ADDENDUM No. 01

Coaldale Government Building

Project No.: 9030

Project:	Coaldale Protective Services Building	File No.	841-004
Client:	Stephens Kozak – ACI Architects and Planners	Addendum No.	S1
Copy:		Date:	February 12, 2019

PROJECT :		STEPHENS KOZAK ACI ARCHITECTS COALDALE PROTECTIVE SERVICES BUILDING	
DRG. TITLE :		REVISED DIMENSION ON SOUTH-EAST CANOPY FRAMING PLAN	
DRAWN :	DATE :	FILE No. :	SKETCH No. :
NM	FEB. 12, 2019	841-004	SSK-024

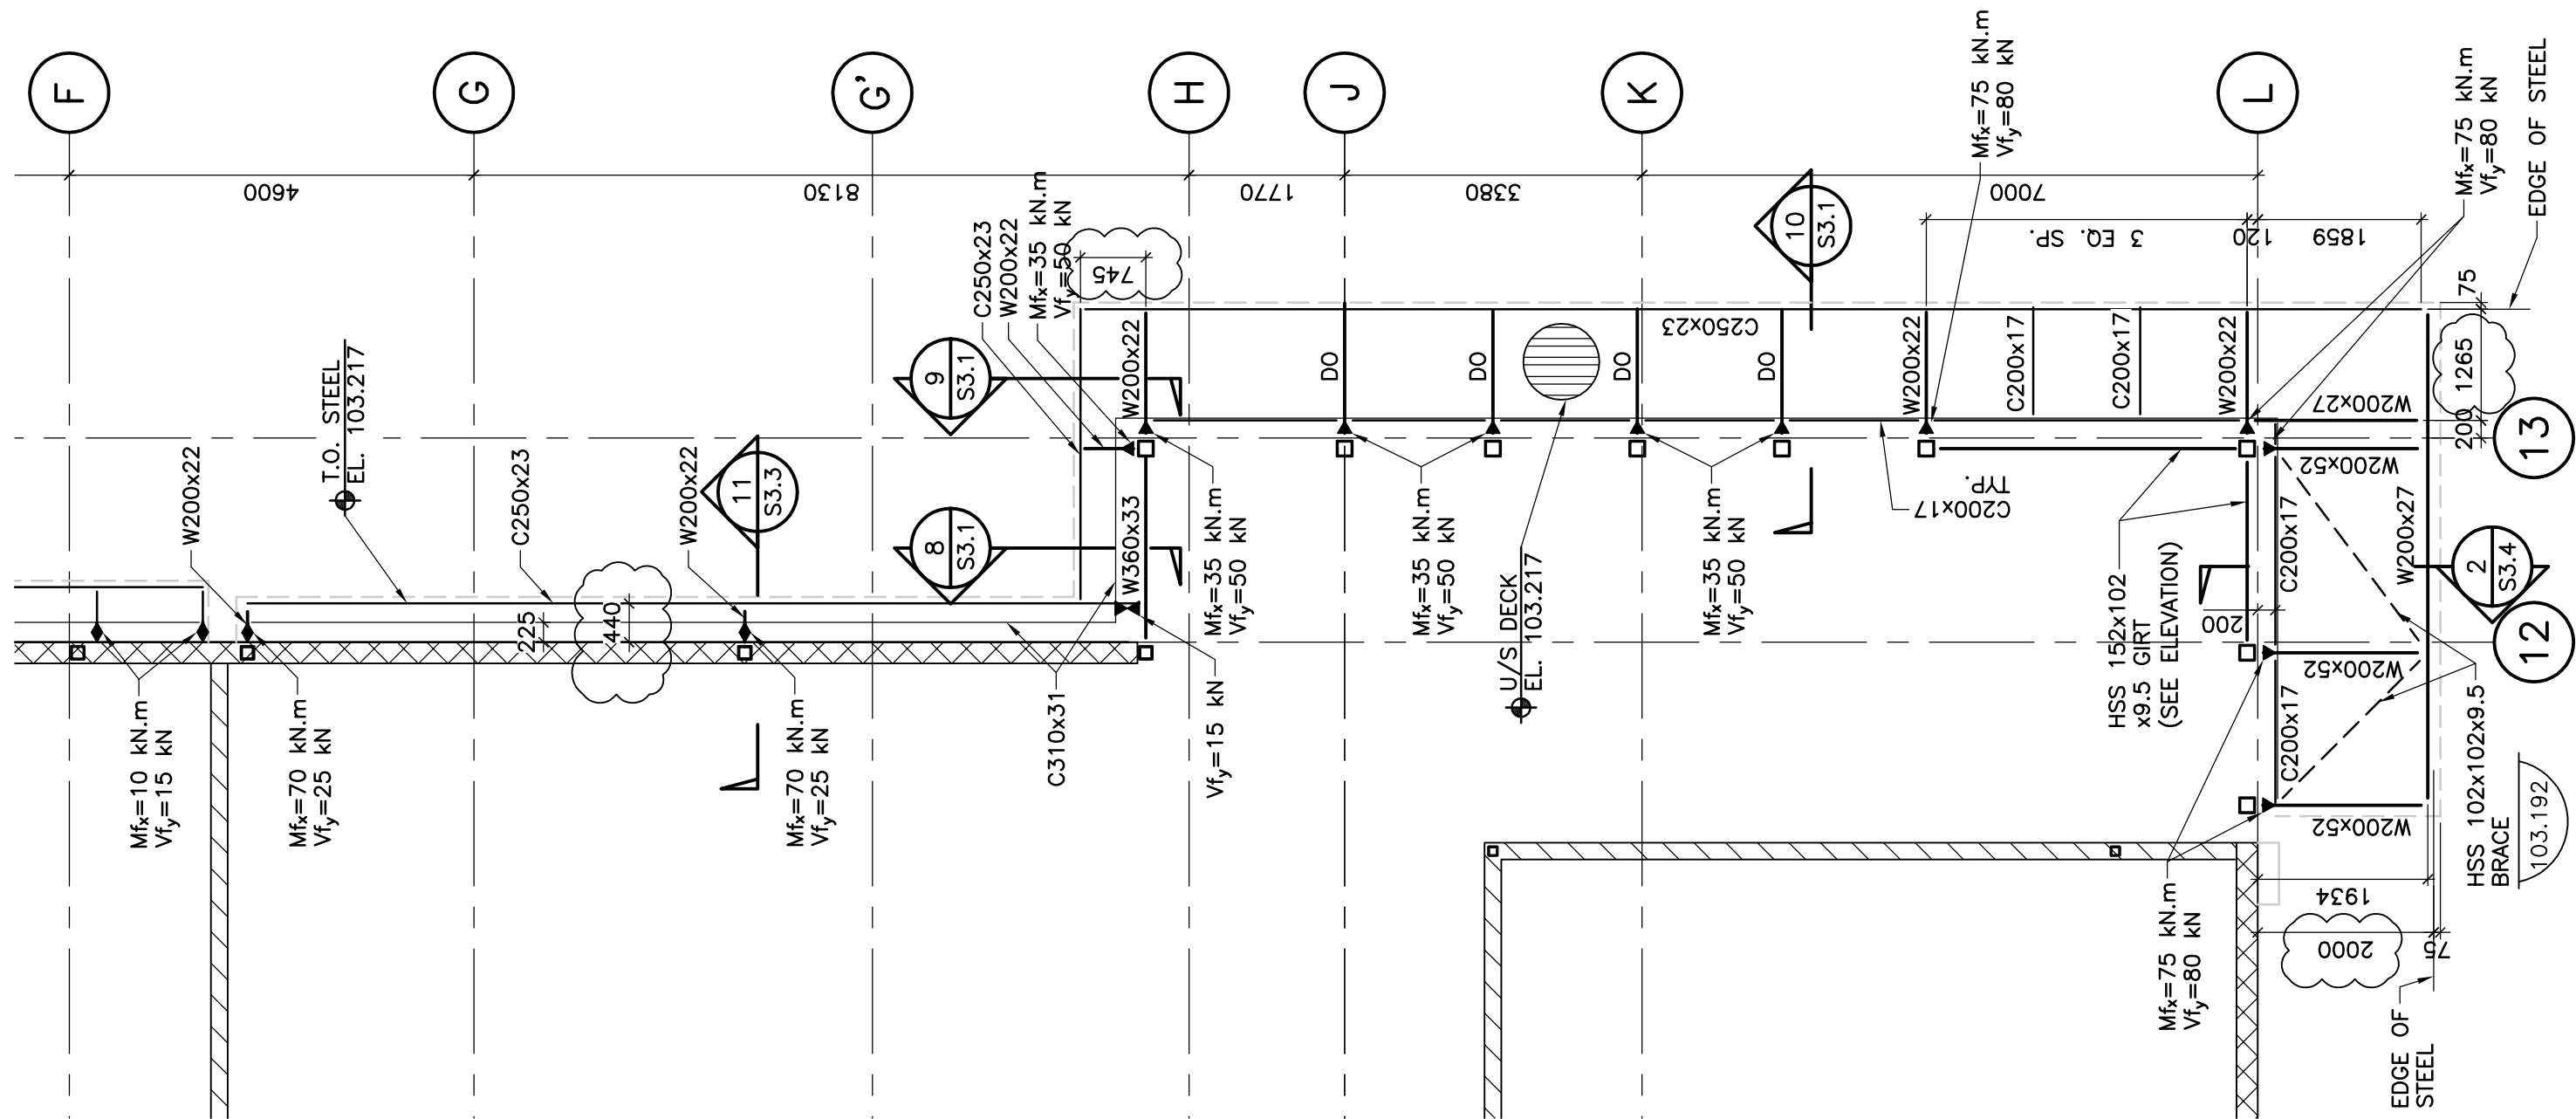
.6.5 On South-East Canopy Framing Plan, along gridline A revise dimension '375' to read '625' as clouded on SSK-024.

Revise dimension of canopy along gridline 12 '375' to read '625' as clouded on SSK-024.

PROJECT : STEPHENS KOZAK ACI ARCHITECTS COALDALE PROTECTIVE SERVICES BUILDING			
DRG. TITLE : REVISED DIMENSION ON SOUTH-EAST CANOPY FRAMING PLAN			
DRAWN : NM	DATE : FEB. 12, 2019	FILE No. : 841-004	SKETCH No. : SSK-025

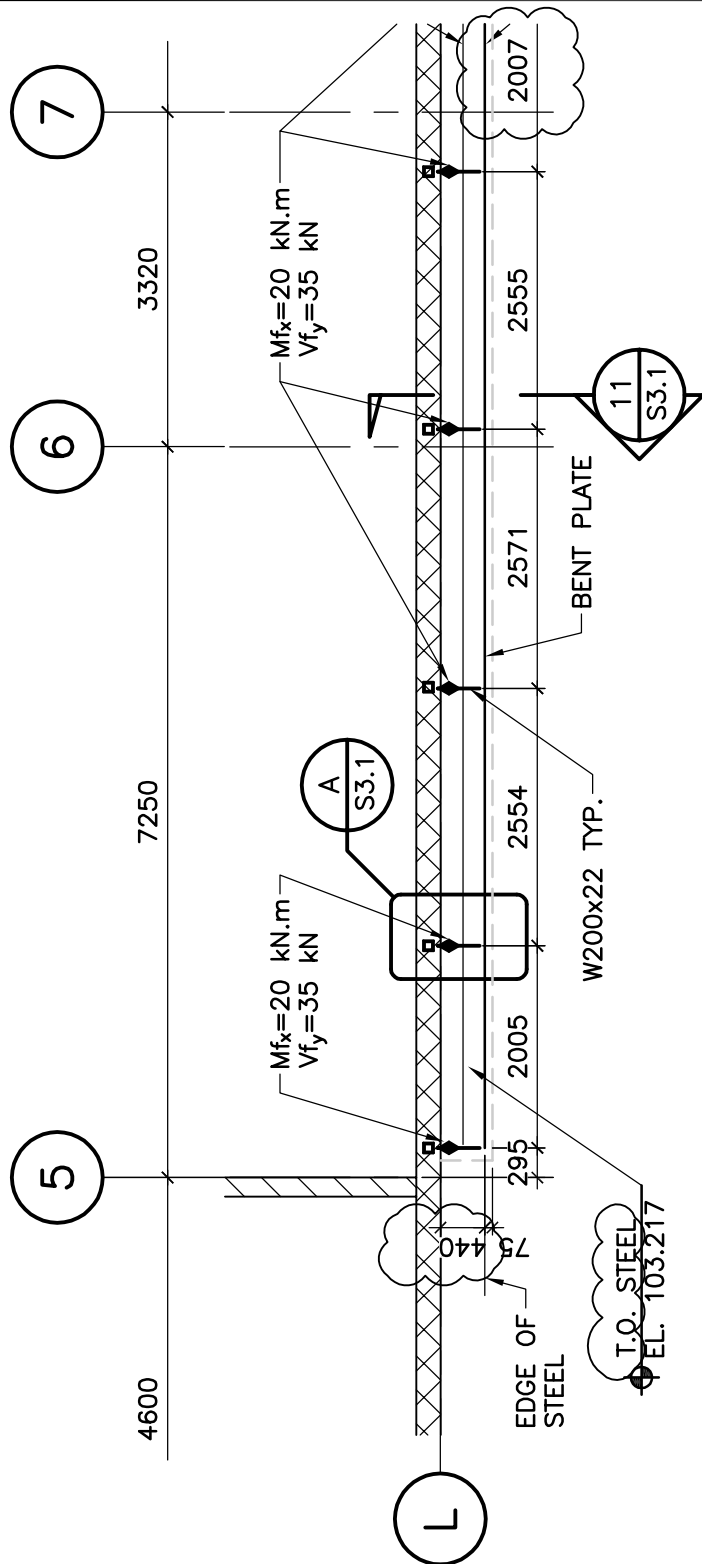
Add canopy dimension '440' along gridline 12 between gridlines G and G' as per SSK-025.

Revise dimension '1925' to read '2000' at south of gridline L as clouded on SSK-025.

DRG. TITLE : REVISED SOUTH CANOPY DIMENSION
BETWEEN GRIDLINES 5 AND 7

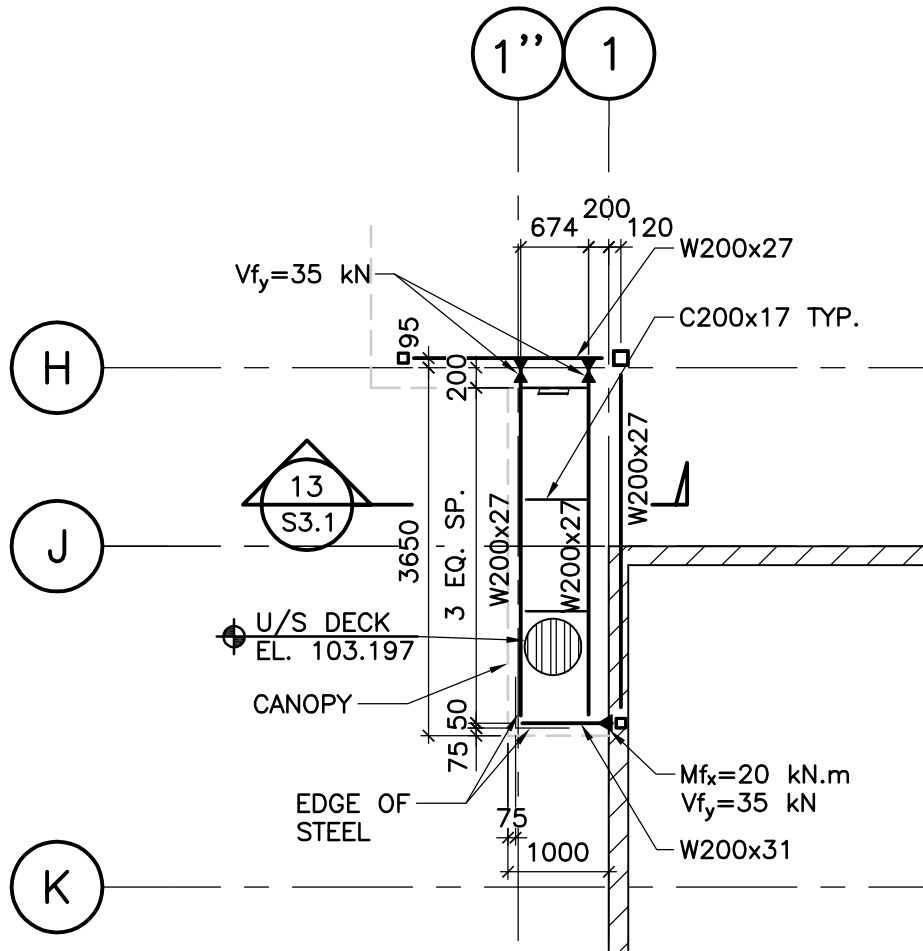
.6.6 On South Canopy Framing Plan along gridline L between gridlines 5 and 7, revise canopy dimension '375' to read '440' and revise U/S Deck to read T.O. Steel and revise dimension '2004' east of gridline 7 to read 2007 as clouded on SSK-026.

PROJECT :		STEPHENS KOZAK ACI ARCHITECTS COALDALE PROTECTIVE SERVICES BUILDING	
DRG. TITLE :		REVISED SOUTH CANOPY DIMENSION BETWEEN GRIDLINES 5 AND 7	
DRAWN :	DATE :	FILE No. :	SKETCH No. :
NM	FEB. 12, 2019	841-004	SSK-027

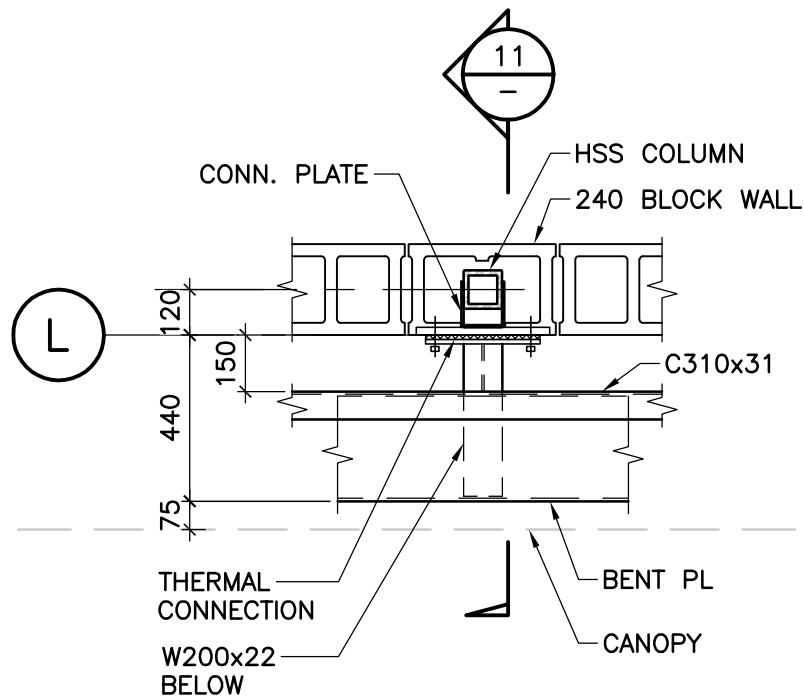
.6.7 Revise South-West Canopy Framing Plan as per SSK-027.

DWG. TITLE: **OUTBUILDING MECHANICAL PLAN (M1.0)**

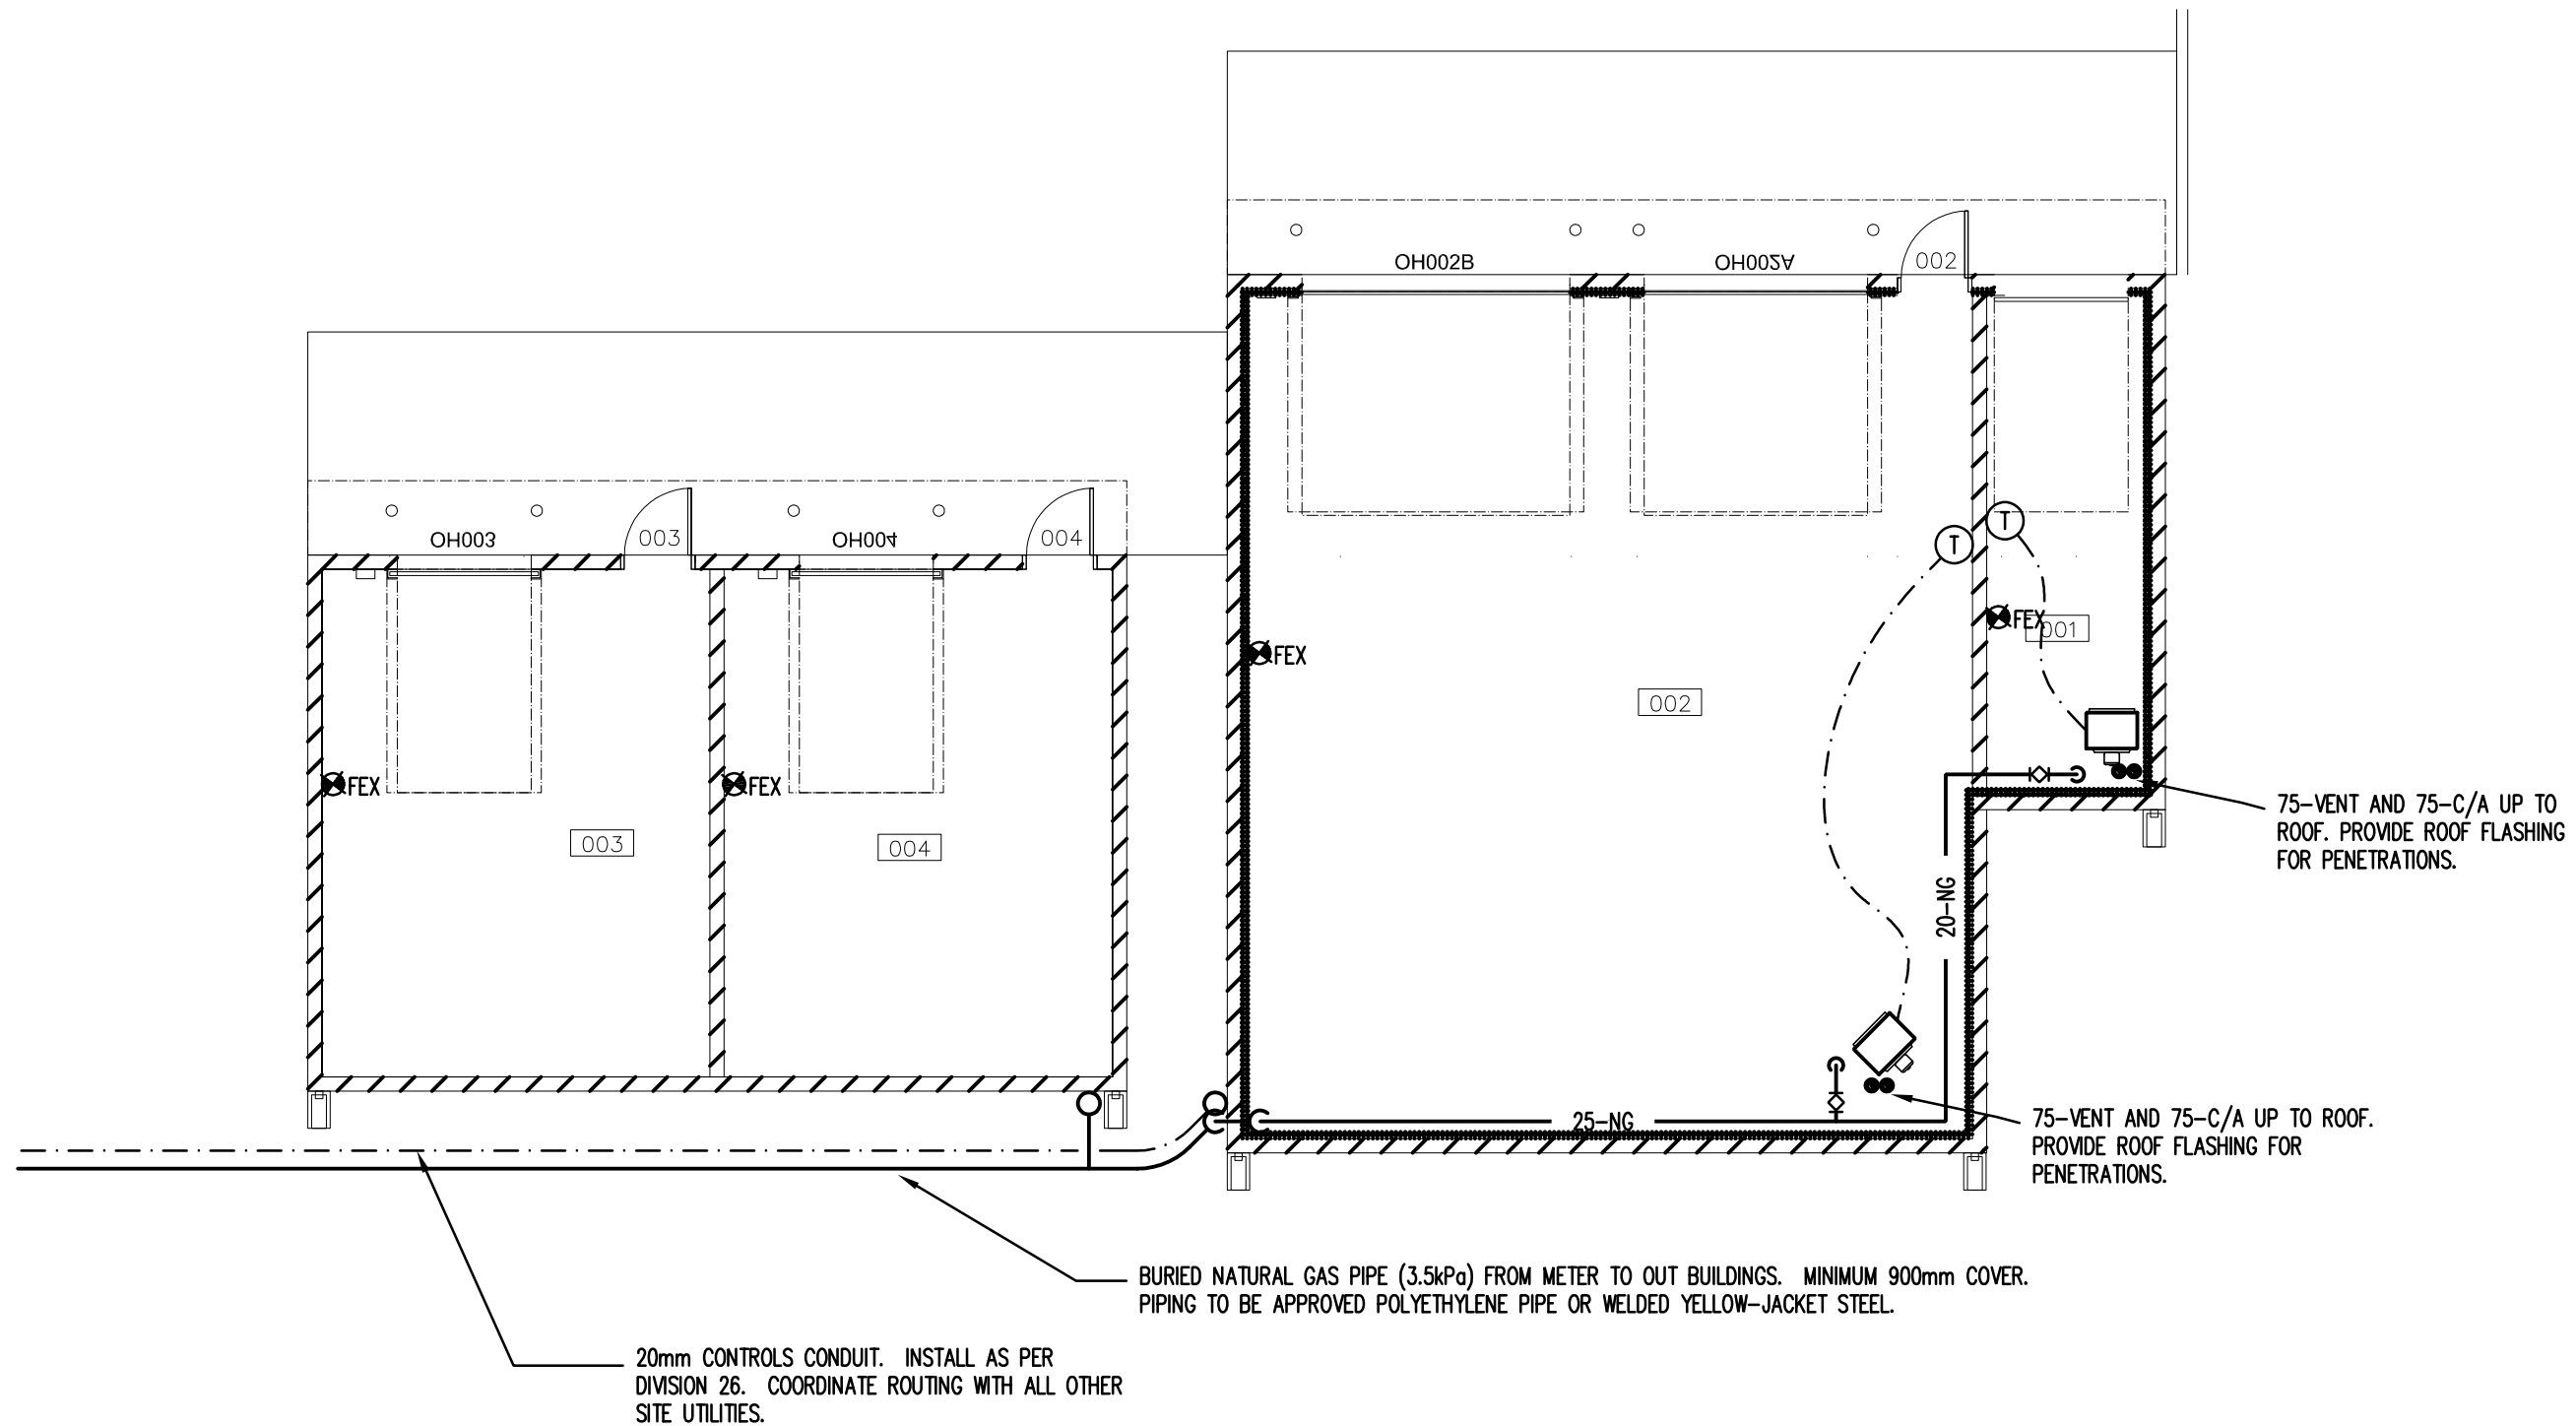
ADD: Add detail 2 to drawing M1.0 as per attached sketch M1.0-MSK-01.

ADD: Add two more FEXs in east Out-Building as per sketch M1.0-MSK-01. All FEXs in out-buildings to be rated -40C operation.
